NATIONAL PARK SERVICE

Re: National Park Service Comments on *Cadiz Groundwater Storage and Dry-Year Supply Program Environmental Impact Statement* and Supporting Technical Documents

Subject: Review of the Cadiz Groundwater Storage and Dry-Year Supply Program Draft Environmental Planning Technical Report, Groundwater Resources, Volumes I and II.

Figure 1.--Delta oxygen-18 and delta deuterium data from Fenner Valley and vicinity

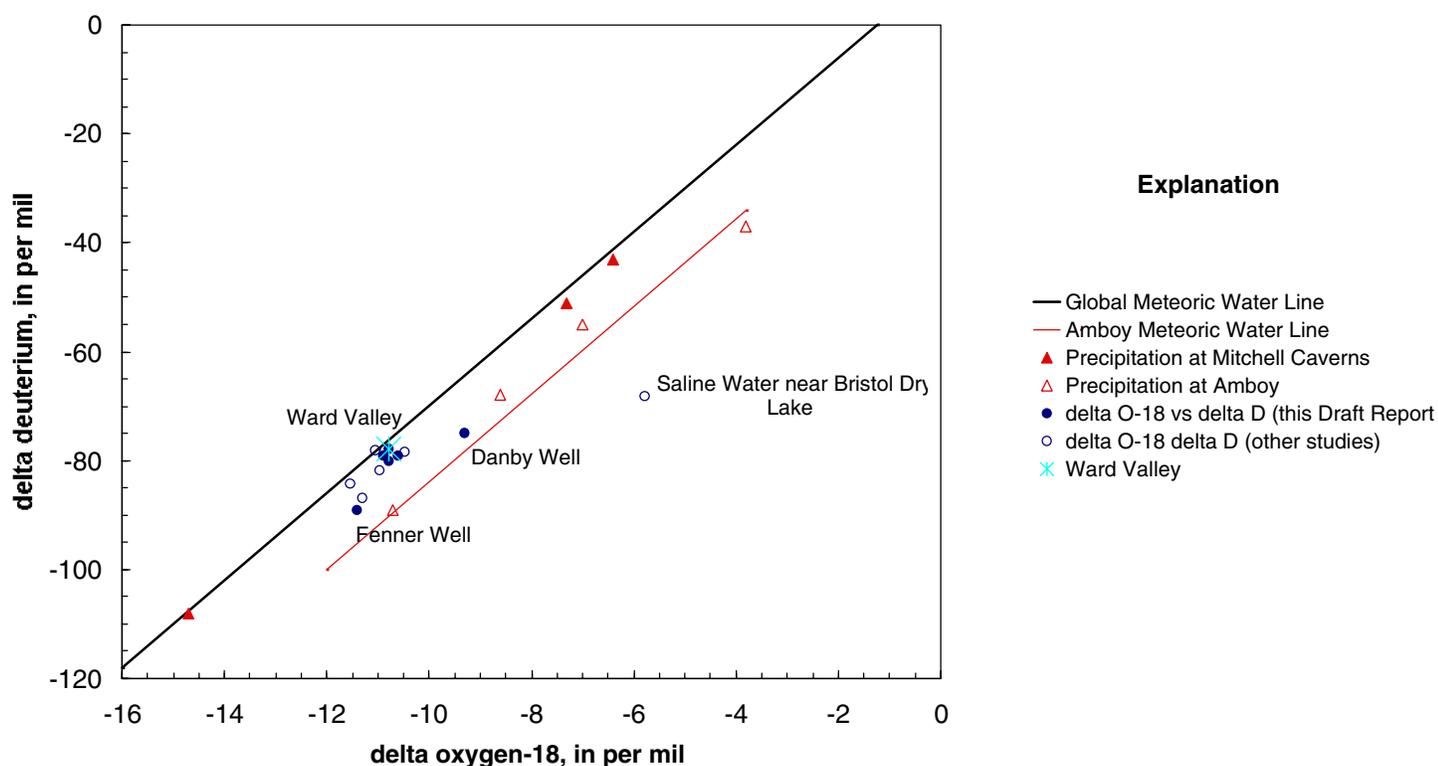
Comments on interpretation of oxygen-18 and deuterium data--The δD and $\delta^{18}O$ isotopic compositions of precipitation collected by Friedman et al. (1992) at Mitchell Caverns and at Amboy (near Bristol dry lake and closer to the study site) are different. Data from Mitchell Caverns plots on the meteoric water line. Data from Amboy plot on a line parallel to, but below, the meteoric water line. The isotopic composition of precipitation data at Amboy relative to the

meteoric water line is typical of precipitation in summer-dominated precipitation regimes of the Mojave Desert and across much of the arid southwestern United States. The isotopic composition of water from Mitchell Caverns is typical of water from cooler, higher altitude sites. The similarity in isotopic composition (both in absolute magnitude and position relative to the meteoric water line) of ground water sampled as part of the Draft Report in the Fenner Gap areas to precipitation at Mitchell Caverns suggests that the ground water originated as recharge from precipitation that fell at a higher altitude rather than from locally derived precipitation. This is consistent with the interpretation presented in the Draft Report and is not consistent with infiltration from Schulyer Wash. Mitchell Caverns and other higher altitude locations are many miles from the study site and ground-water flow paths through alluvial aquifers are long.

Water from the Danby well (this Draft Report) plots below the meteoric water line along the local meteoric water line at Amboy. Its position along the Amboy meteoric water line suggests a locally derived origin for water from this well. This is consistent with the interpretation presented in the Draft Report and the δD and $\delta^{18}O$ composition of water from the Danby well is cited as evidence of infiltration from washes that drain Fenner Valley. However, if infiltration is occurring along the wash, why is there no isotopic or chemical evidence of water from this source in the Fenner Gap wells? Similarly, data from an upgradient well along the wash at Essex (LaMoreaux & Associates, 1995) show no evidence of infiltration from the wash. Friewald
